# CITY PLAN COMMISSION STAFF REPORT

**Chaves (Formerly SeaBiscuit)**

## Docket #10 Request

- .1 - CD-CPC-2020-00065 – Rezoning.
- .2 - CD-CPC-2020-00066 – Signage Plan.
- .3 - CD-CPC-2020-00067 – Development Plan.

COUNCIL APPROVED SIGNAGE PLAN

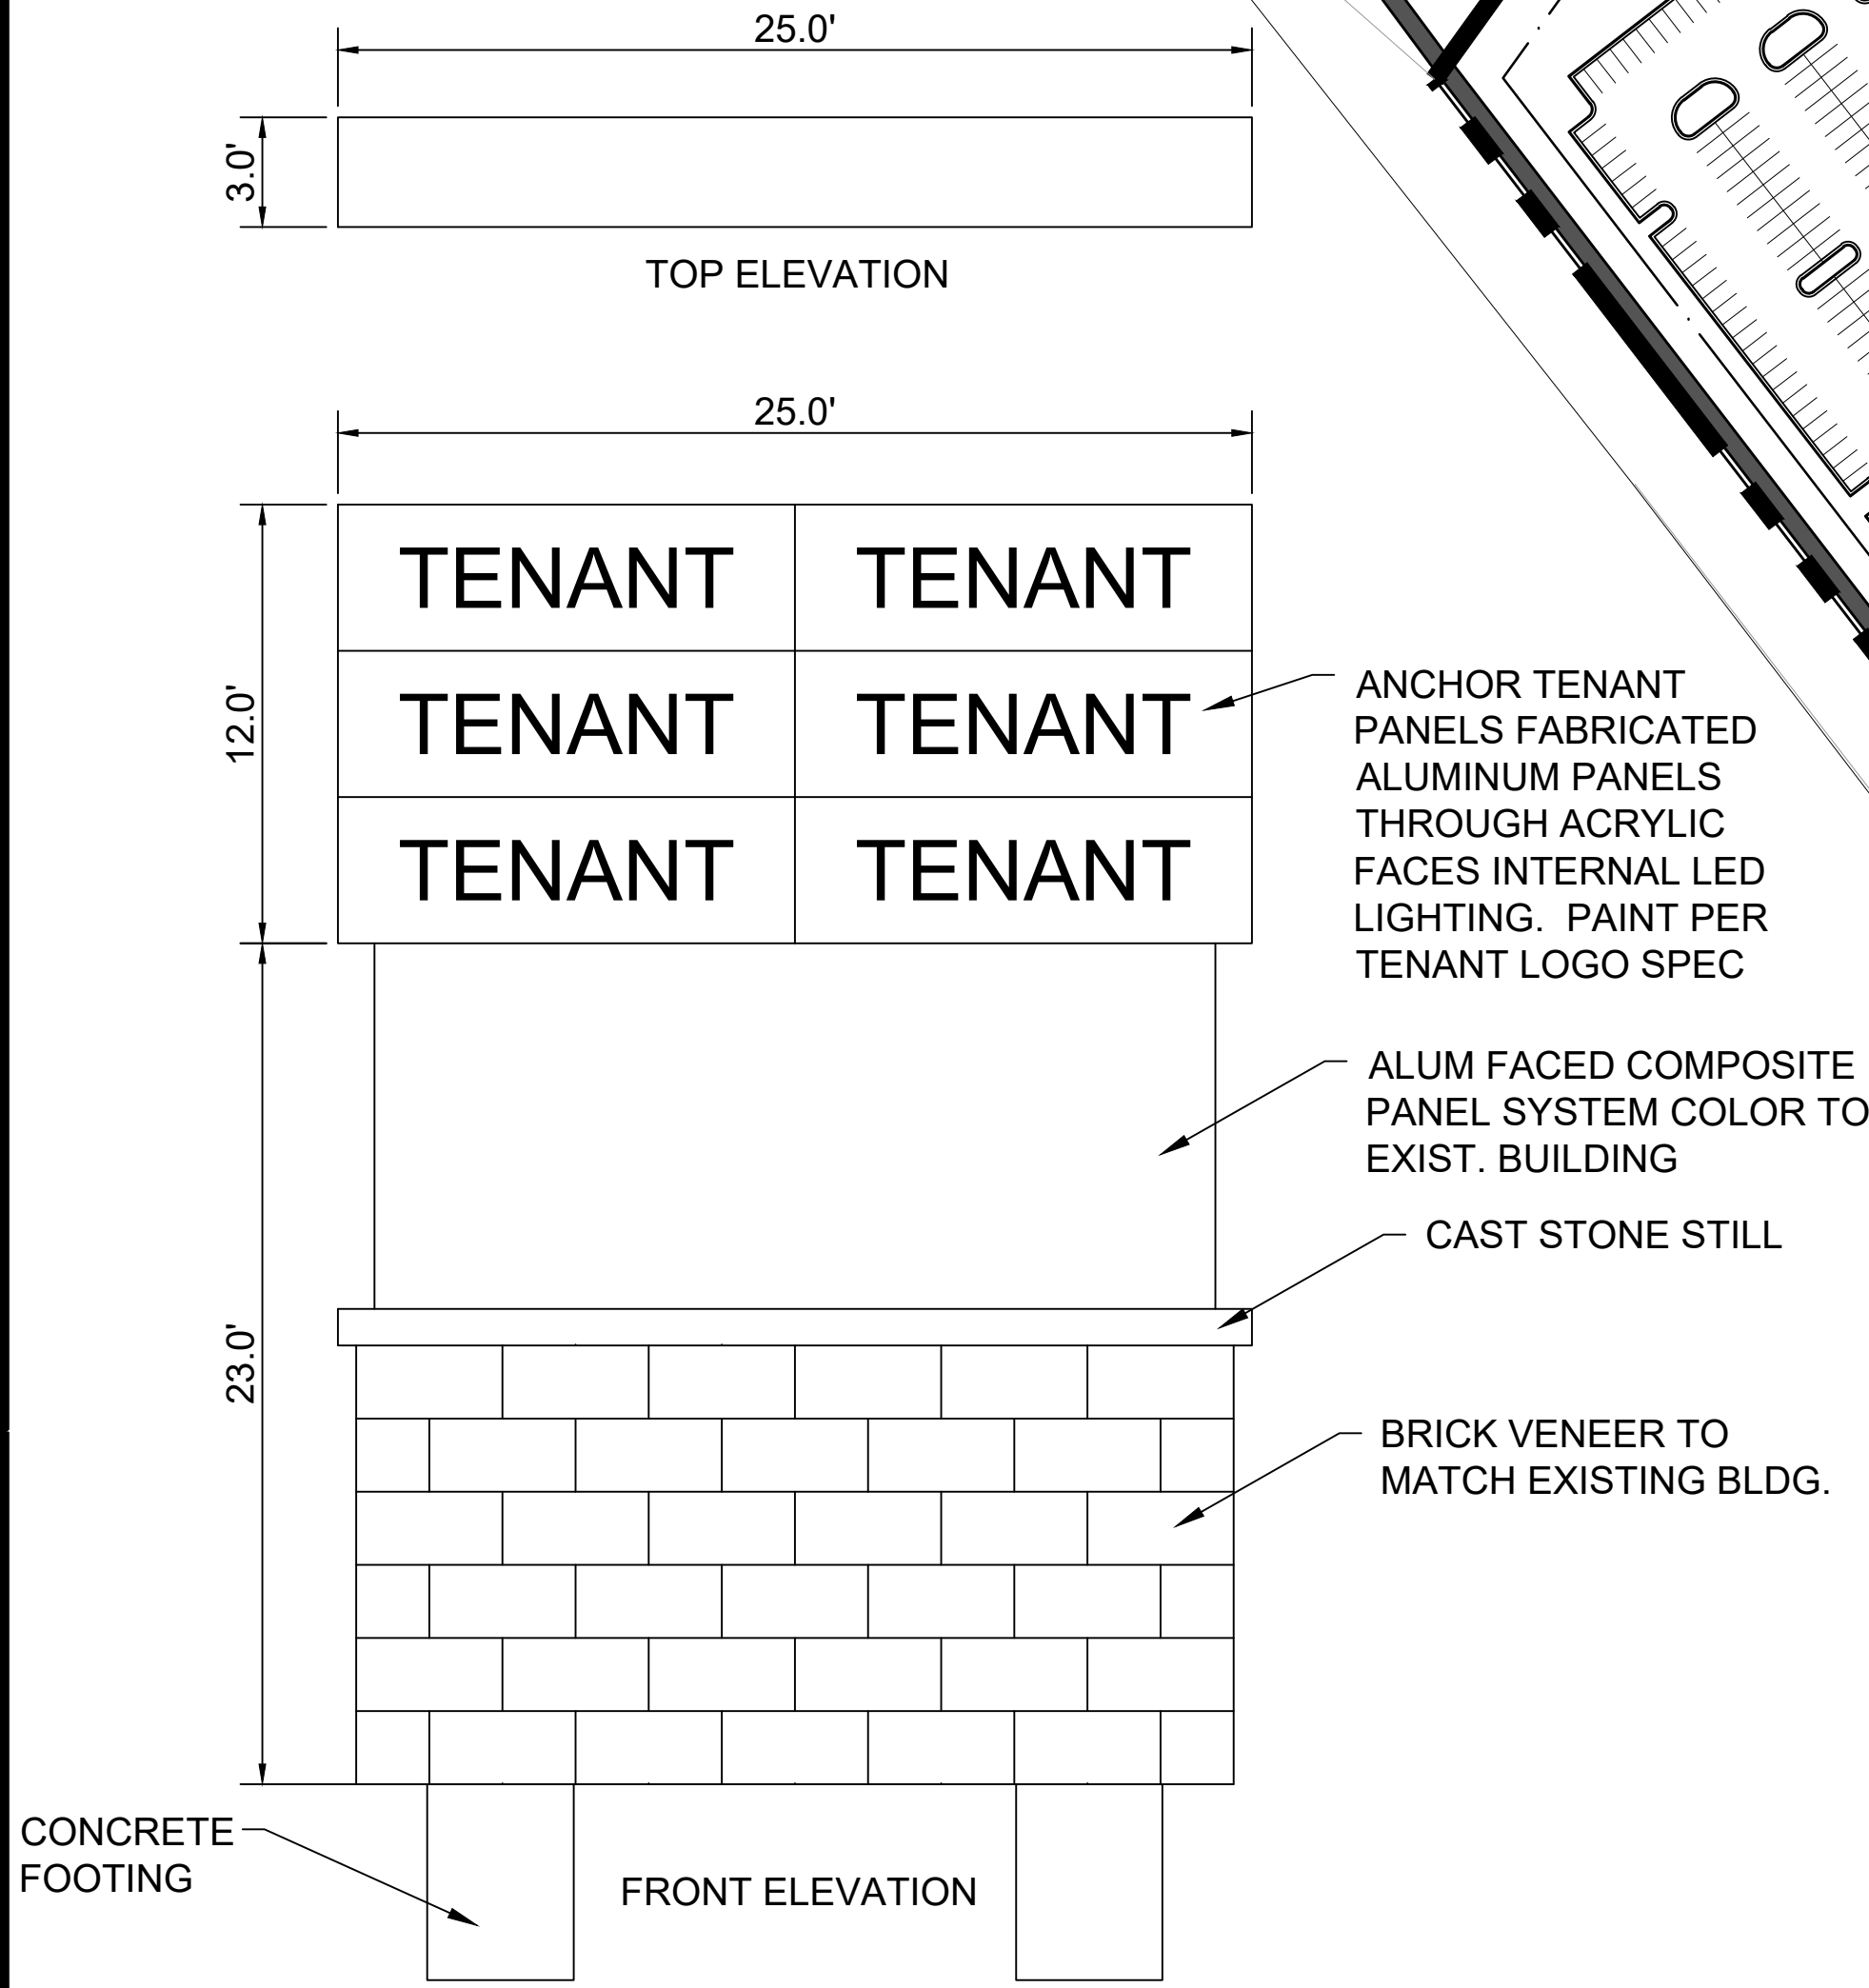
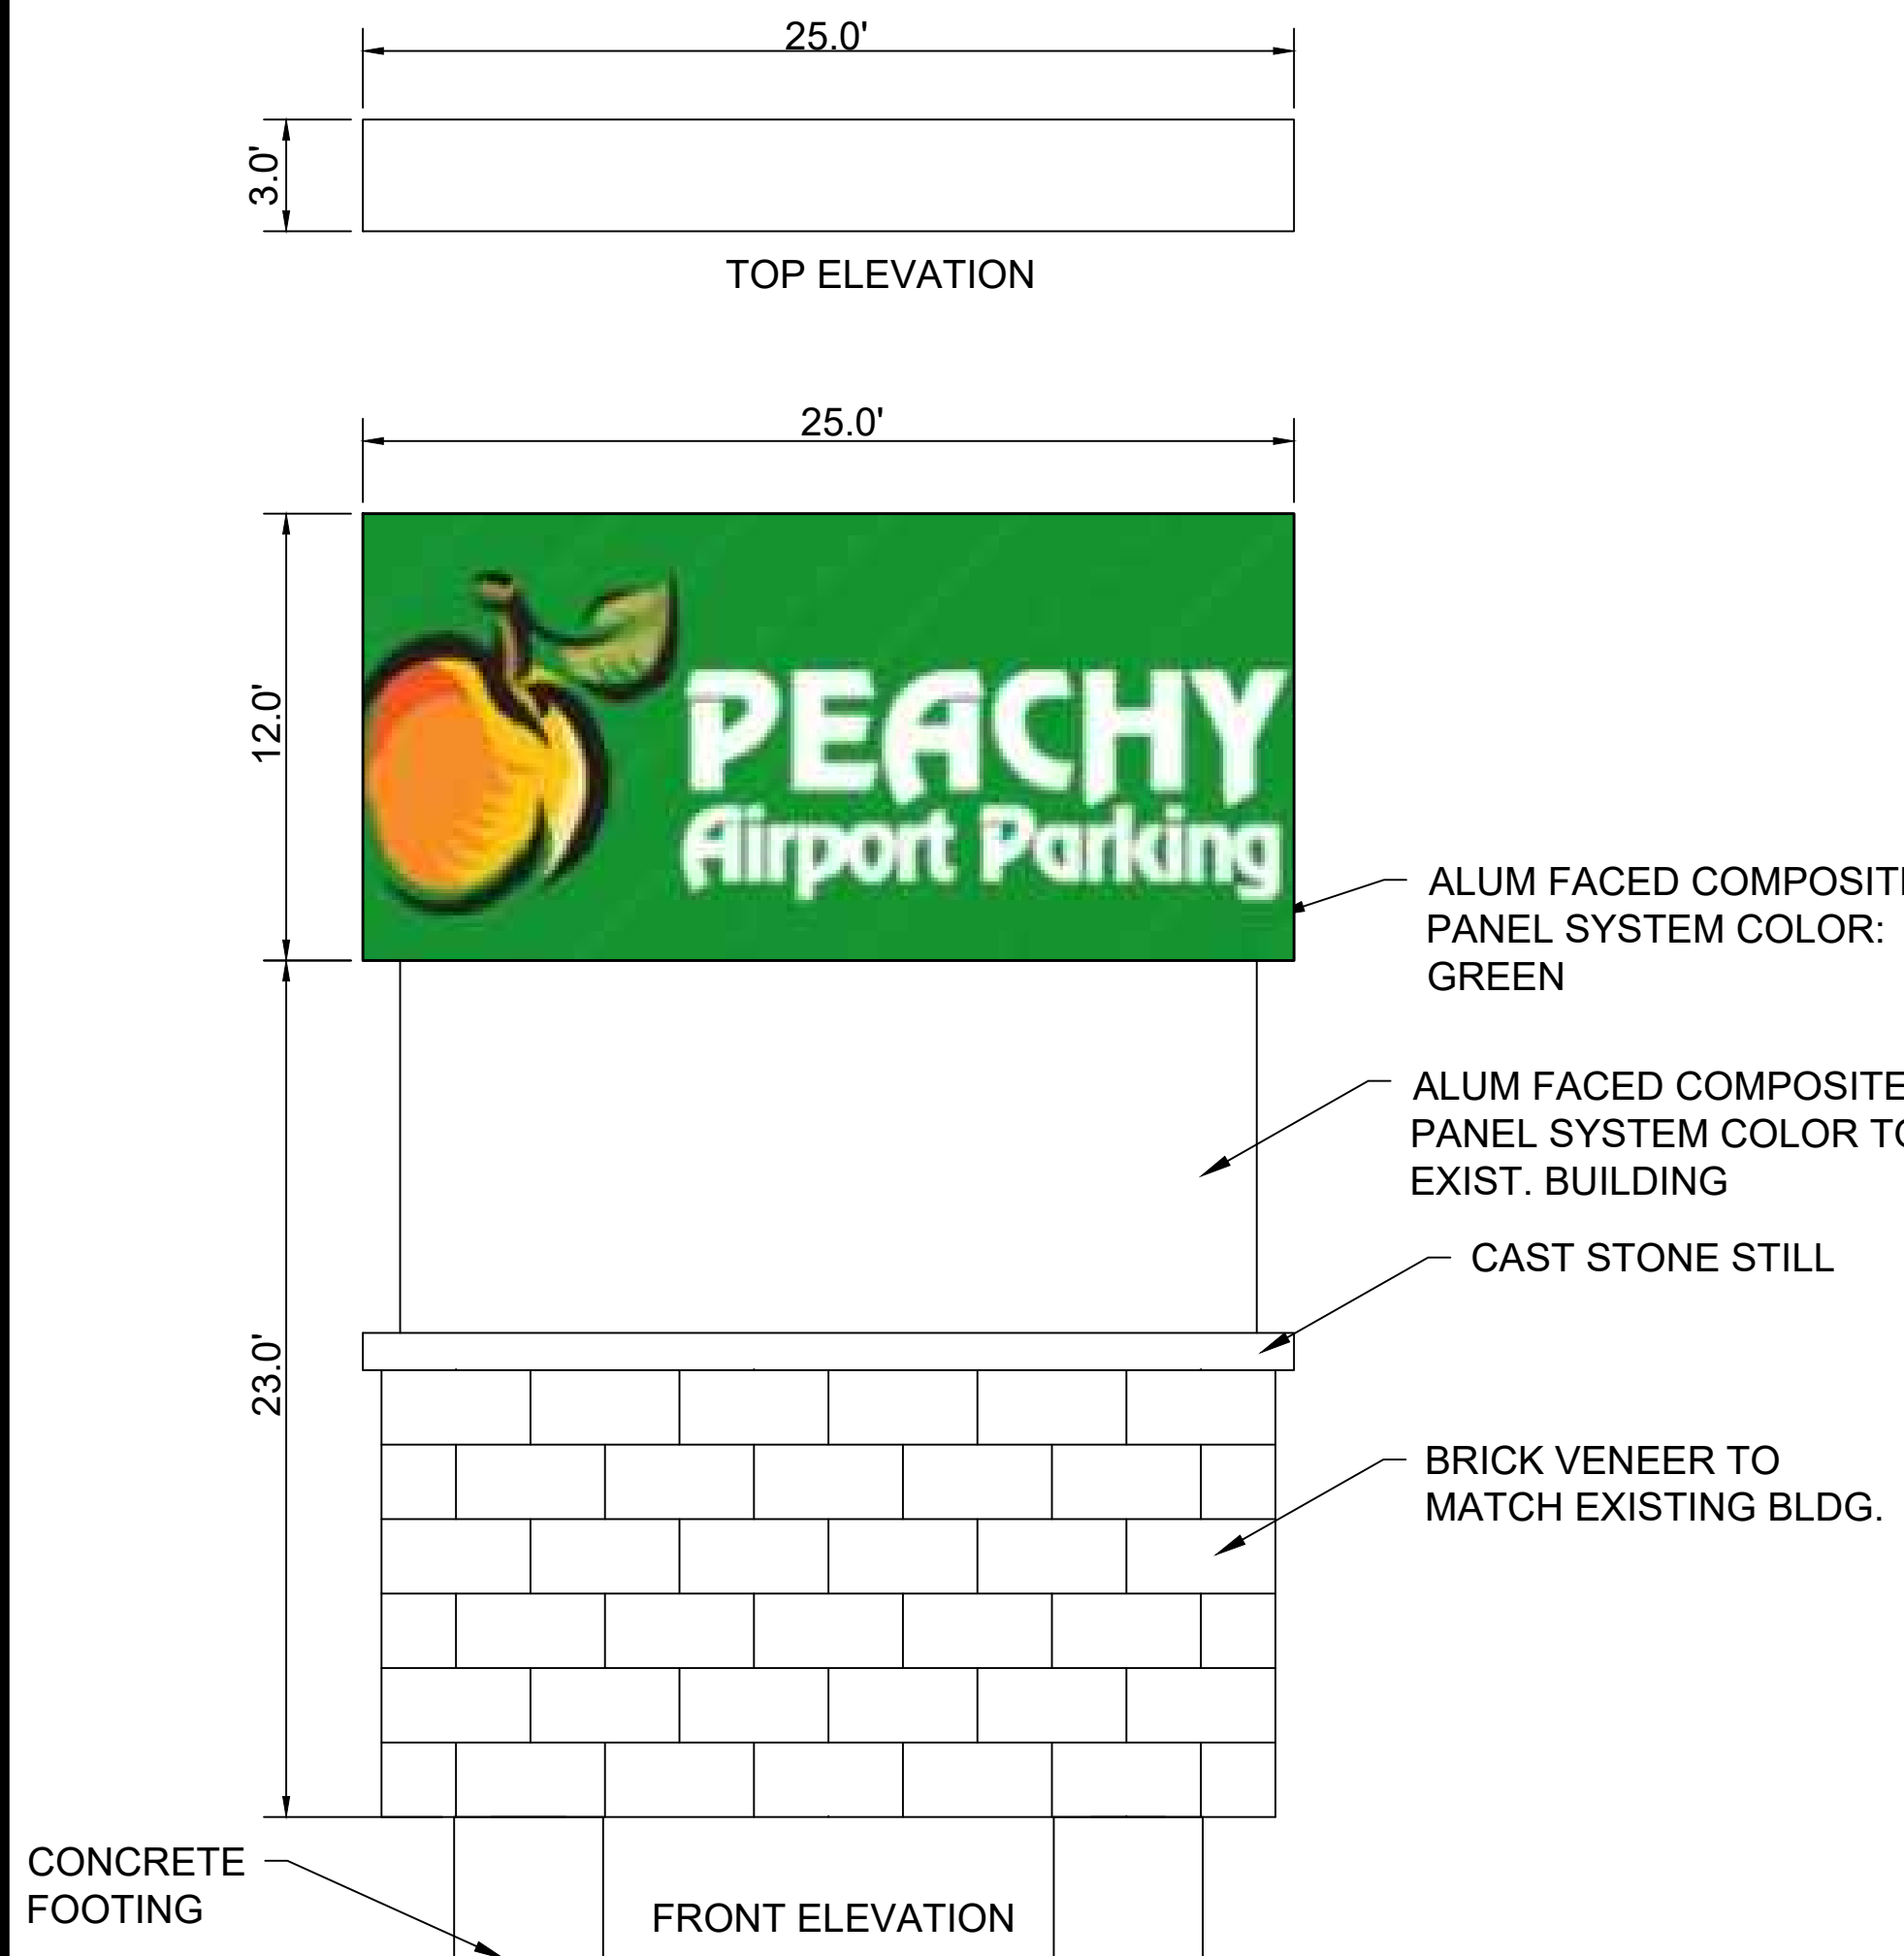
**Case No. CD-CPC-2020-00066** is a request for approval of a Council Approved Signage Plan in District B3-3 (Community Business - 3) pursuant to Section 88-445-11 to allow for three oversized Monument signs as part of the Chaves Development. The proposed signs are 35 feet in height and 300 square feet in size. The signs are proposed to be constructed of aluminum faced composite materials on a brick base with and aluminum clad composite middle to match adjacent buildings. The main entry sign will be a single user sign and the other two signs will have up to 6 tenant panels. The signs must be setback 20 feet from the property line. Staff recommends some revisions to show the actual sign (25' wide) on the site plan.

The applicant is proposing to install several oversized monument signs as a companion case. Staff recommends that the plan be revised to properly show locations of all proposed signage for this development. The revised plan shall be approved prior to ordinance request.

1. Provide an approximate timeline of when each oversized monument sign will be constructed with the phases of the related Development Plan. (5/12/2022)
2. Staff recommends that the southwest sign should incorporate multi-tenant signage as well. It is the closest to the interchange and major intersections as well as the western main drive to the development. (5/12/2022)
3. Assuming the paid parking lot is constructed first, what will the anticipated colors be of those that say to match the existing building? The existing office tower or proposed commercial buildings? (5/12/2022)

4. If the associated Development Plan (CD-CPC-2020-00067) should expire, this associated Council Approved Signage Plan shall be deemed expired as well. (4/27/2020)
5. The proposed oversized monument signs shall not be constructed into the associated lot or tract of land where the sign will be placed is platted. (4/27/2020)
6. No oversized monument sign permit shall be issued until permits for Phase 1 of the development are issued to constructed either necessary infrastructure or building permits. (4/27/2020)
7. Vacate the existing right-of-way for NW 122nd Ct in association with any future Final Plats. (4/29/2020)
